Notice of Allowability

09/628,929

CARGNELLI ET AL.

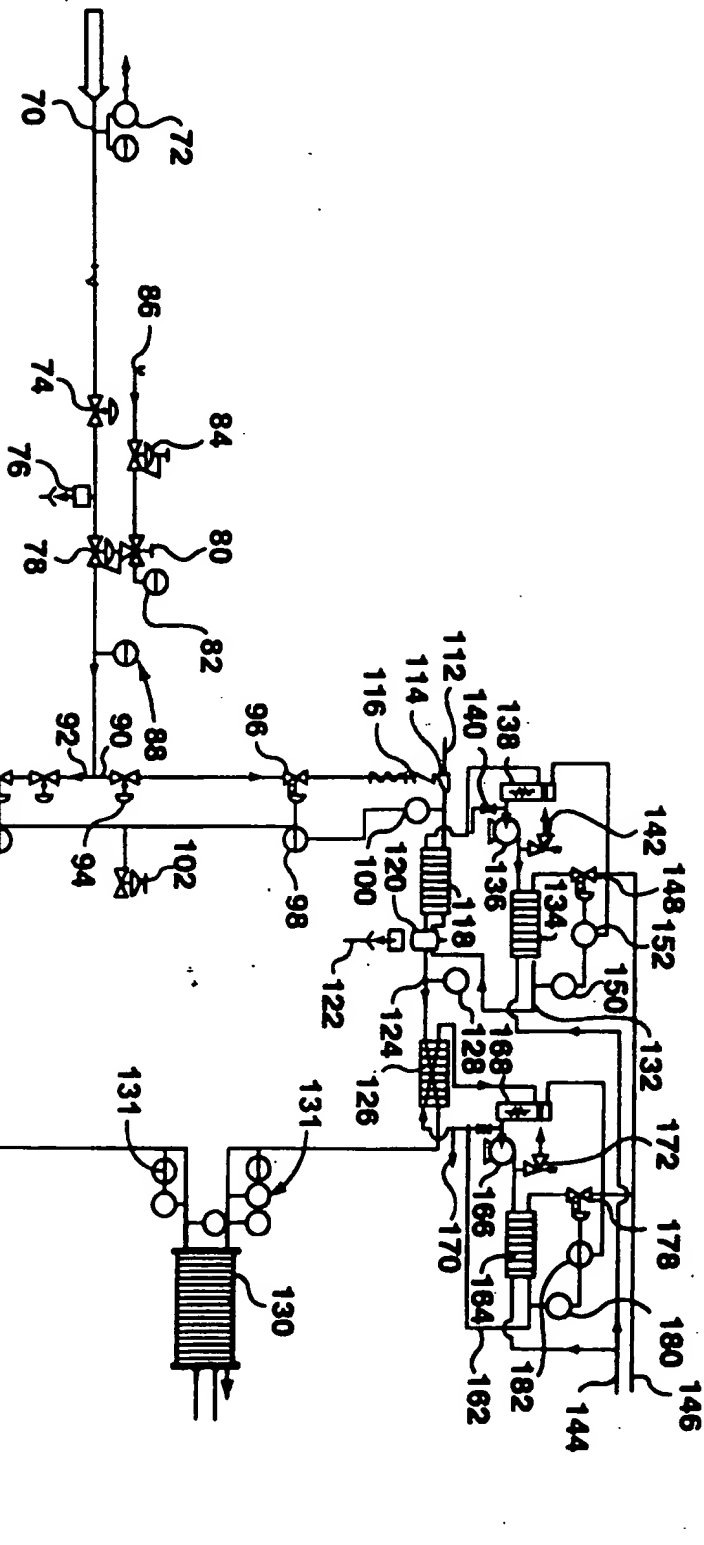
An examiner's comment to the record appears below. The proposed drawing correction of September 12, 2005 did not make its way into the electronic file until after the office action mailed September 20, 2005 was mailed. Consequently, it was not addressed in that office action. The proposed drawing correction of September 12, 2005 contains "new matter" unsupported by the original disclosure.

Most notably the heat exchanger (newly legended 134a) immediately below heat exchanger 118a in originally filed Figure 7 now has a plurality of fluid connections associated with it that are not supported by the original specification, claims or drawings. The fact that the systems in the upper and lower portions of Figure 7 are disclosed as similar on page 9, lines 8-12 of the originally filed specification (note the term "many" and not "all" being used to describe the correspondence of the elements between the upper and lower portions of Figure 7) does not permit applicant to engage in wholesale reconstruction of drawing Figure 7. Conduits 144a and 146a are also new and unsupported by the original disclosure.

Not approved

new ~~small~~
